## TIMKEN - HUB UPDATE

# HUB INFORMATION

# PRODUCT BULLETIN

SP470200 / SP470201 – December 2009

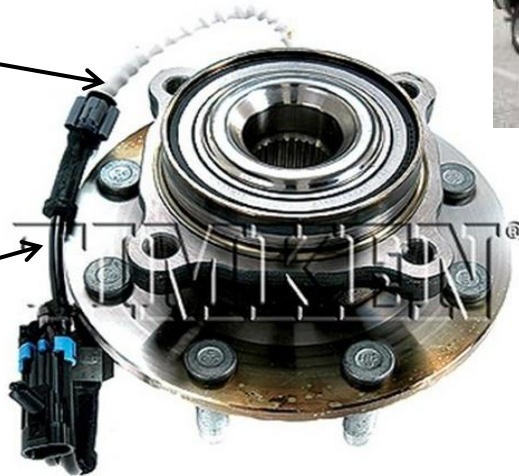
It has come to our attention that GM **"MAY"** have made a mid-model year change to bearing assemblies for SOME 2007 applications listed below.

Both hubs look exactly a like EXCEPT the earlier verison has larger size ABS Sensor Wire and White Boot coming off sensor connection.
